**LAND USE APPLICATION SUMMARY**

*Property Location:* 510 Cedar Avenue South  
*Project Name:* 510 Cedar Avenue South  
*Prepared By:* Hilary Dvorak, Principal Planner, (612) 673-2639  
*Applicant:* Garad Nor  
*Project Contact:* Jerry Anderson with Jamb Architects  
*Request:* To construct a new 10,100 square foot mixed-use building.  
*Required Applications:*

<b>Variance</b>	To reduce the minimum parking requirement from 10 to 0 spaces.
<b>Site Plan Review</b>	For a new 10,100 square foot mixed-use building.

**SITE DEVELOPMENT PLAN**

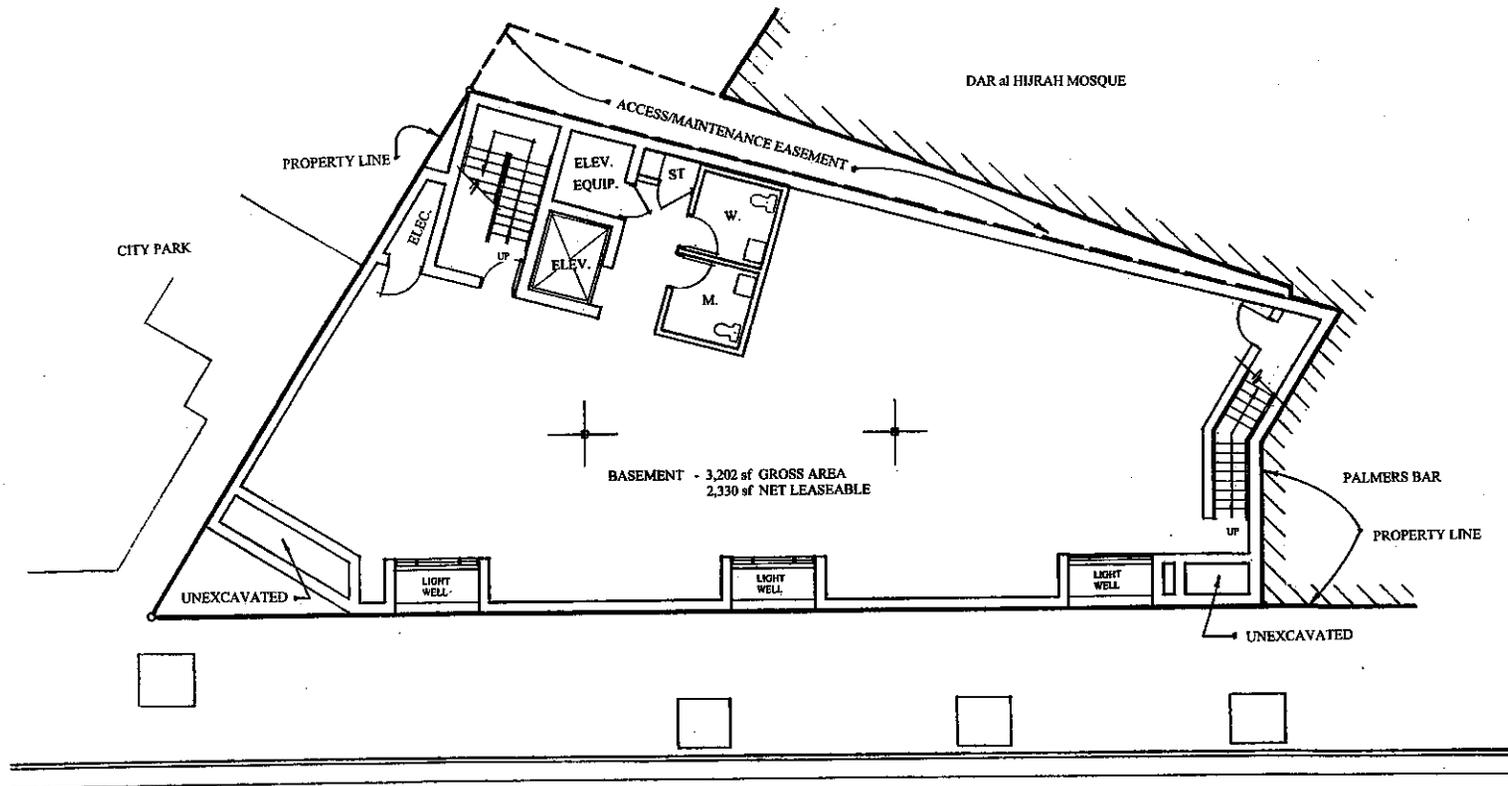
- The first floor of the building is located between zero and 11 feet from the front property line along Cedar Avenue. The portion of the building that is set back 11 feet from the front property line is in the southeast corner of the building where one of the principal entrances is located. Alternative compliance is required.
- The placement of the building reinforces the street wall, maximizes natural surveillance and visibility, and facilitates pedestrian access and circulation. The building will be located close to the front property line, there will be entrances at street level and there will be large windows on the street facing sides of the building that maximize the opportunities for people to observe adjacent spaces

- At least 20 percent of the site not occupied by the building shall be landscaped. The applicant is not proposing any landscaping on site (see Table 2). Alternative compliance is required.
- The tree requirement for the site is one and the applicant is not proposing to provide any trees on the site. Alternative compliance is required.
- The shrub requirement for the site is one and the applicant is not proposing to provide any shrubs on the site. Alternative compliance is required.

- **Landscaping.** Thirteen square feet of landscaping is required to be provided on the site. In addition, one tree and one shrub are also required. The applicant is not proposing to provide any landscaping on the site. Given the size of the site CPED is recommending that the City Planning Commission grant alternative compliance.

**WEST ELEVATION**

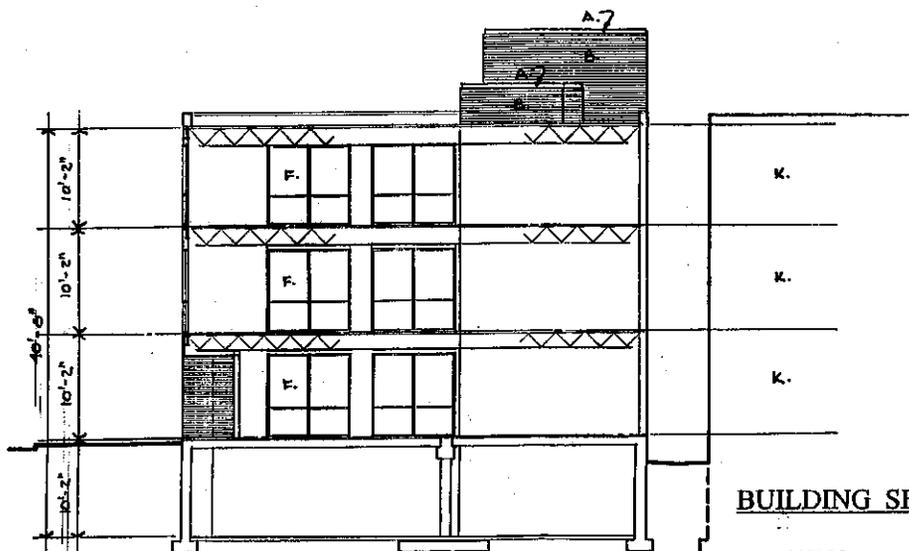
- The building walls provide architectural detail and contain windows in order to create visual interest.
- The back (or west) wall of the building contains areas that are blank and over 25 feet in length. Alternative compliance is required.

- **Blank walls.** The back (or west) wall of the building contains areas that are blank and over 25 feet in length. Given the size of the site the west wall of the building is proposed to be located up to the west property line. In addition, this wall of the building abuts an access and maintenance easement which is located adjacent to another building. CPED is recommending that the City Planning Commission grant alternative compliance.
